File SPR-1996-102

Name: Business Residence – 640 West Gunnison Avenue – Site Plan Review

SPR-96-102 Site Plan Review--Business Residence, 640 W. Gunnison Avenue
Community Development Department Review--Kathy Portner
5/3/96

REVIEW COMMENTS

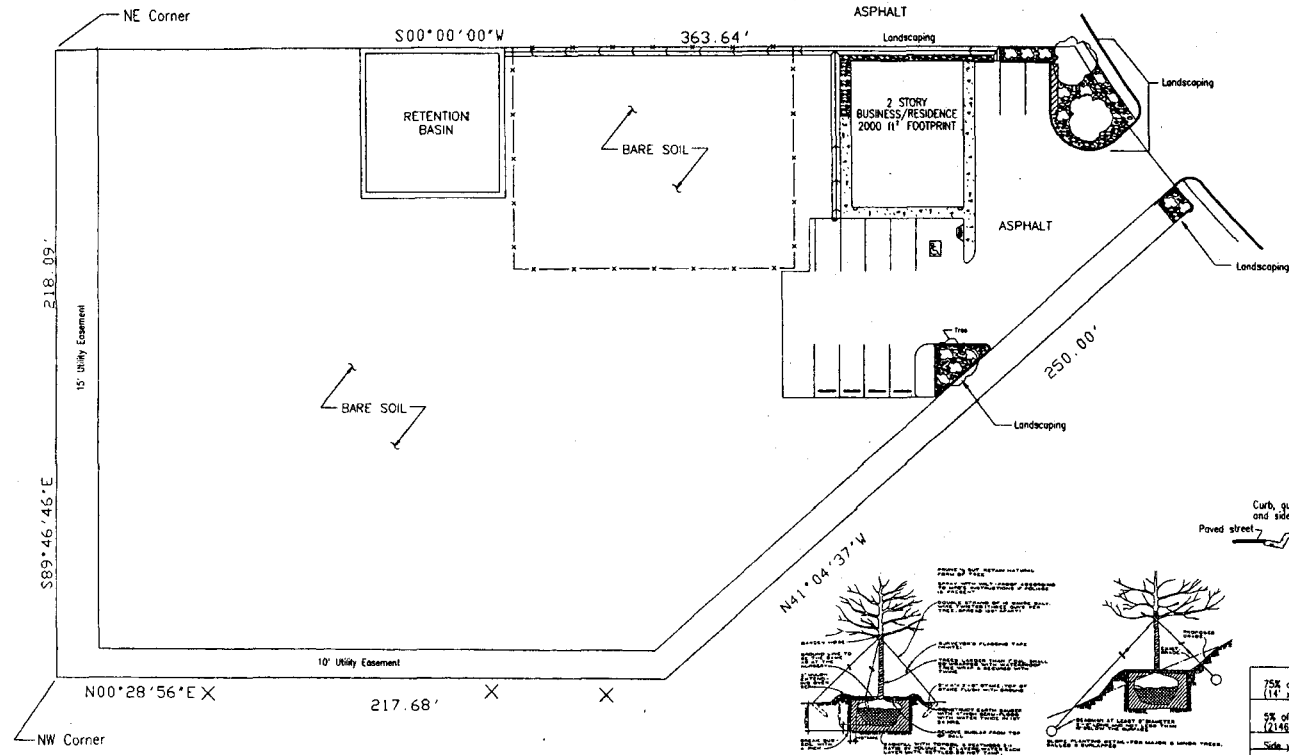
Move this corner 5' to the west

Project	Landscaping Plan
Scale	As Shown
Date Drawn	May 9, 1996
Latest Revision	Revision 1
Sheet	3 of 4

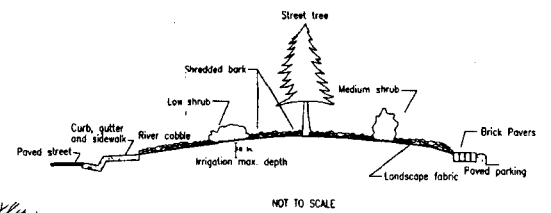
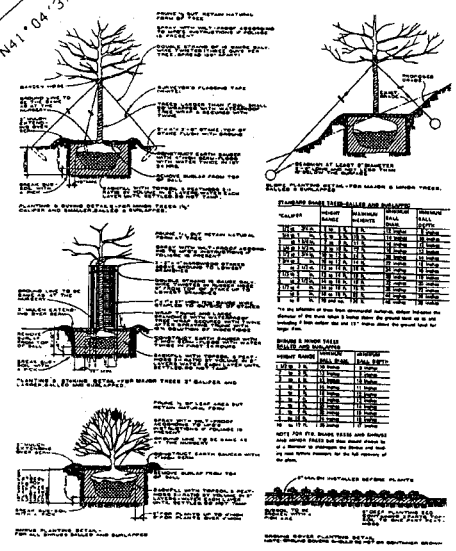
Comment: Based on the 70 ft of street frontage, 263 s.f. of landscaping is required, including a minimum of 1 tree and 40% shrub coverage. The s.f. shown far exceeds the standard. The required street trees are in addition to the 1 tree required based on the required landscaping. One additional tree must be provided. Staff recommends it be located in the parking island adjacent to the bike rack.

Comment: The minimum planting size for evergreens is 6' in height. The landscaping note should be changed for the planting size of the Austria Pine.

Response: One additional tree has been added in the parking island adjacent to the bike rack.

Response: Change made as requested.

Site Plan / Utility Composite
 DW&K Investments
 640 West Gunnison
 Grand Junction, CO 81505

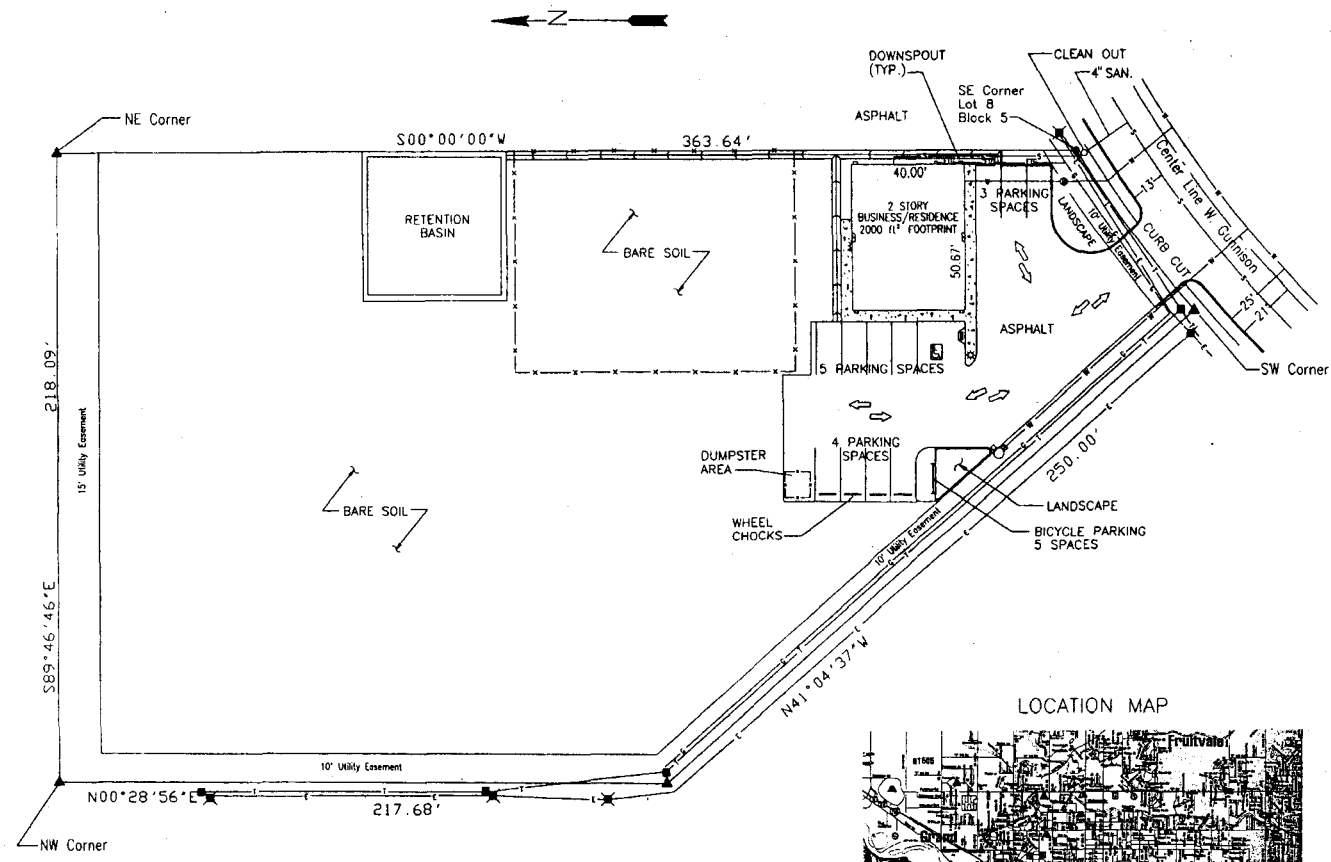
Comment: An additional fire hydrant is required along W. Gunnison. This hydrant should be located along the south side of Gunnison and across from the proposed entrance.

Comment: Please indicate proposed sewer and water service line on Utility Composite

Response: Per our phone conversation of May 8, an additional fire hydrant will be installed in the utility easement on the west side of the subject property as shown on the revised site plan map.

Response: The Utility Composite has been revised to show the lines. They were inadvertently placed on the Grading and Drainage plan and left off of the Site Plan.

Project	Grading and Drainage Plan
Scale	As Shown
Issue Date	May 9, 1998
Client	DW&K Investments
Revision	1
Sheet	5 of 5

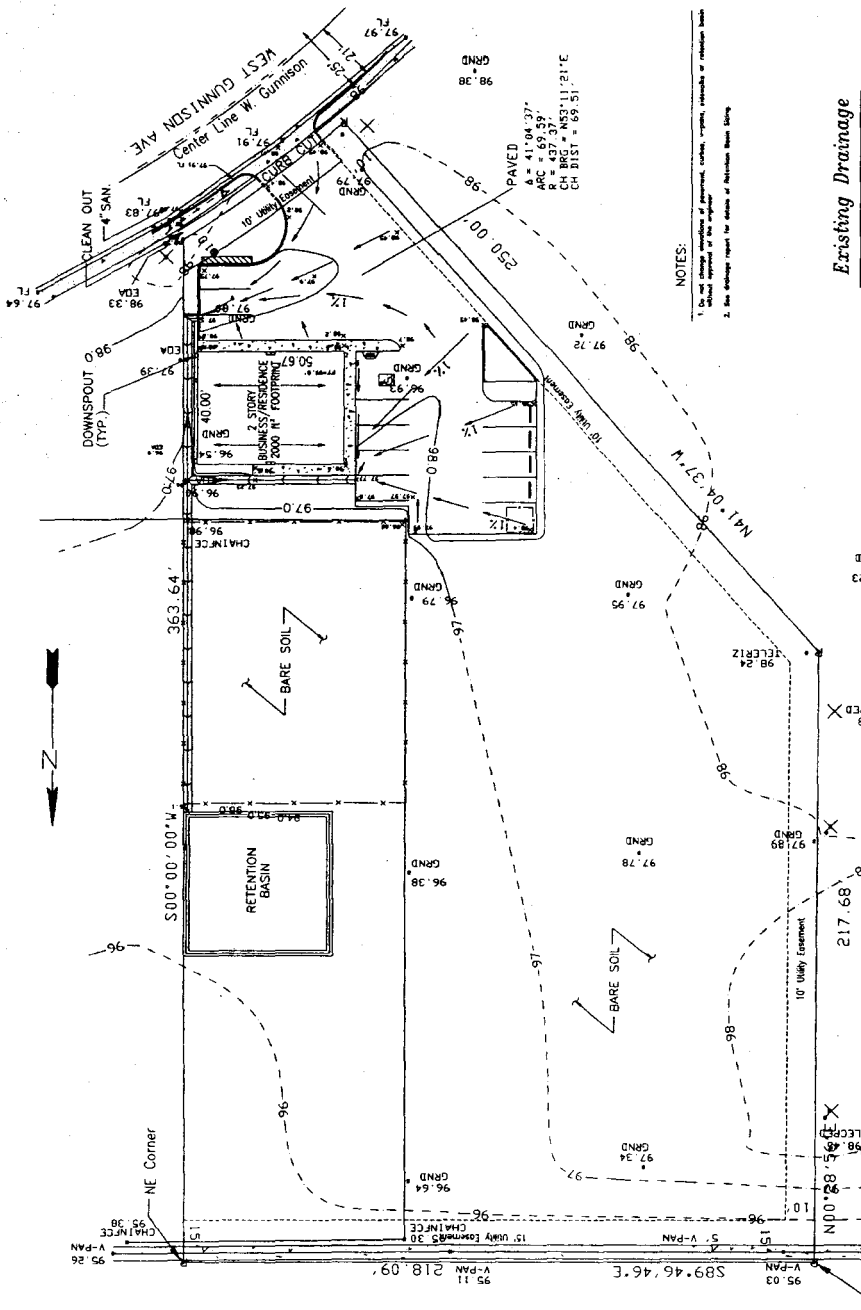
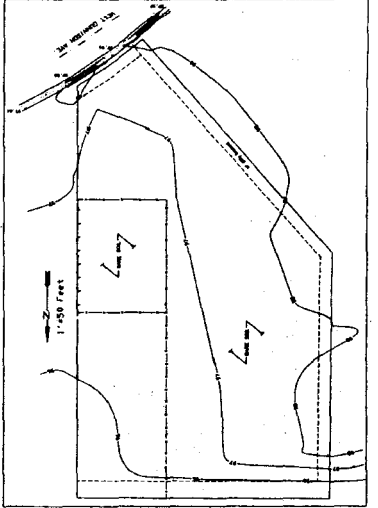
Comment: Please provide calculations for the proposed retention pond.

Response: An addendum to the drainage plan has been prepared showing the retention pond calculations.
